# Access Compliance Report

## Public Rights-of-Way

| Intersection ID: 8132                   | Main Street: OLD_CONCORD_RD | Cross Street: BRANCH_HILL_CR | Location: W                             |
| ADA ID: C0A936EC2944                    | Ramp Type: Perp             | Initial Pass/Fail: Pass      | Overall Compliance: No                  |

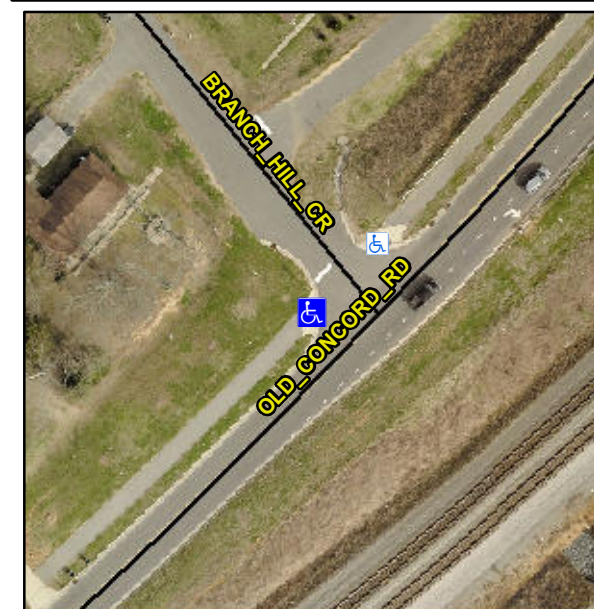
**Not Found, R304.2.1, R304.2.2-Perp,  
R304.3.2-Para, R304.5.3, R305.1.4,  
R302.7, R304.5.4**

| Compliance | Description           | Data   | Compliance | Description                 | Data |
|------------|-----------------------|--------|------------|-----------------------------|------|
| No         | Landing Width (in)    | 24.0   | Yes        | DWS Contrast?               | Yes  |
| No         | Landing Slope (%)     | 5.0    | No         | DWS Length (in)             | 23.5 |
| No         | Landing X Slope (%)   | 3.3    | Yes        | DWS Full Width?             | Yes  |
| No         | Gutter Ponding?       | Yes    | No         | Gutter Slope (%)            | 7.3  |

**Remove & Replace Entire Ramp.  
Remove & Replace Gutter.**
